SUBJECT: SUSQUEHANNA STEAM ELECTRIC STATION, UNITS 1 AND 2 - ISSUANCE  
OF AMENDMENT RE: CHANGE TO TECHNICAL SPECIFICATIONS FOR THE  
RESIDUAL HEAT REMOVAL SERVICE WATER SYSTEM AND ULTIMATE  
HEAT SINK (TAC NOS. MB2119 AND MB2120)

These amendments revise TS 3.7.1 to add operability requirements and surveillance requirements for the ultimate heat sink spray bypass and large array valves, and reduce the allowed Completion Times for the conditions applicable to the residual heat removal service water system.

SAFETY EVALUATION BY THE OFFICE OF NUCLEAR REACTOR REGULATION  
RELATED TO AMENDMENT NO. 206 TO FACILITY OPERATING LICENSE NO. NPF-14  
AND AMENDMENT NO. 180 TO FACILITY OPERATING LICENSE NO. NPF-22  
PPL SUSQUEHANNA, LLC  
ALLEGHENY ELECTRIC COOPERATIVE, INC.  
SUSQUEHANNA STEAM ELECTRIC STATION, UNITS 1 AND 2  
DOCKET NOS. 50-387 AND 388

SSES RHRSW, ESW and UHS System Interfaces and Boundaries

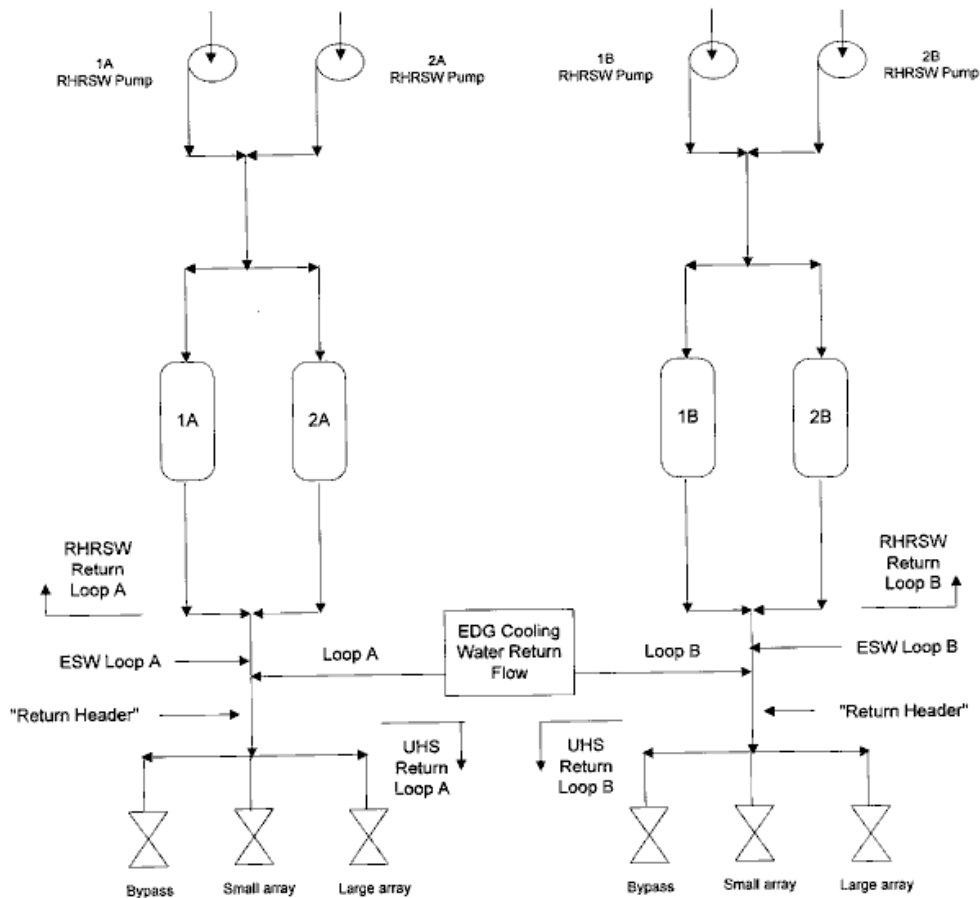
The staff reviewed the application, the Updated Final Safety Analysis Report, previous license amendments and safety evaluations related to these systems, applicable piping and instrumentation diagrams, and responses to the RAIs noted above. The licensee described the RHRSW and UHS systems in the application for amendment. The licensee provided a schematic of the RHRSW/UHS system, which is reproduced as Figure 1 of this evaluation.

The RHRSW system is composed of two loops, with two subsystems assigned to each loop. Each subsystem contains a suction source, one pump, a return header, a heat exchanger, valves, piping and associated instrumentation. The return header is shared with the emergency service water (ESW) system and the other RHRSW subsystem in that loop. The RHRSW pump, taking suction from the ultimate heat sink, pumps cooling water through the tube side of

the RHR heat exchanger. After removing heat from the RHR heat exchanger, the water is discharged back to the UHS through the return header. The return header directs the return flow from both RHRSW subsystems and the ESW system to a network of UHS return loops. The return loops are manually controlled and can route the return flow through the spray arrays, where the heat is dissipated directly to the atmosphere, or the spray bypass lines, where the return flow, and consequently the discharged heat, goes directly to the UHS. One of the two large spray arrays or the combination of both small spray arrays is sufficient to remove the shutdown heat load from a design-basis event. The individual RHRSW loops may be aligned to either unit, as required. The minimum requirement for the safe shutdown of both units, under either normal or accident conditions, is that two of these RHRSW subsystems must be operable.

The UHS return loops must be manually aligned to use either set of spray nozzles. Alignment to either array requires manual closure of the spray array bypass valves, which are automatically opened on RHRSW or ESW pump start. The spray bypass valves are normally open and receive an automatic open signal on RHRSW/ESW pump start to prevent the possibility of running the pumps under dead-head conditions. Use of the spray arrays also requires the manual opening of either the large or the small spray array valves, or both valves, if available. Analysis of the design-basis accident for the UHS shows that one large spray array is required to dissipate the heat generated during a design-basis loss-of-coolant accident (LOCA), with concurrent safe shutdown of the non-LOCA unit.

The failure of a spray bypass valve in one UHS return loop to close on demand results in the inability to use the spray arrays on that UHS return loop. The licensee determined this failure to be the worst-case single failure for the combined RHRSW/UHS system. The licensee's UHS design analysis has concluded that, with a spray bypass valve open, opening either of the spray array valves on the affected subsystem would not produce sufficient spray nozzle pressure to effectively transfer the heat load to the environment. Operations staff would not manually load RHRSW pumps on a UHS return loop that has a failed spray array bypass valve, according to plant procedure. Thus, the failure of a spray array bypass valve to close effectively causes two of the four RHRSW subsystems (the subsystems on the loop that contains the failed valve) to be unavailable. The UHS analysis does account for the alignment of ESW system heat loads on the UHS return loop with the failed bypass valve; therefore, the affected ESW subsystems need not be considered inoperable.
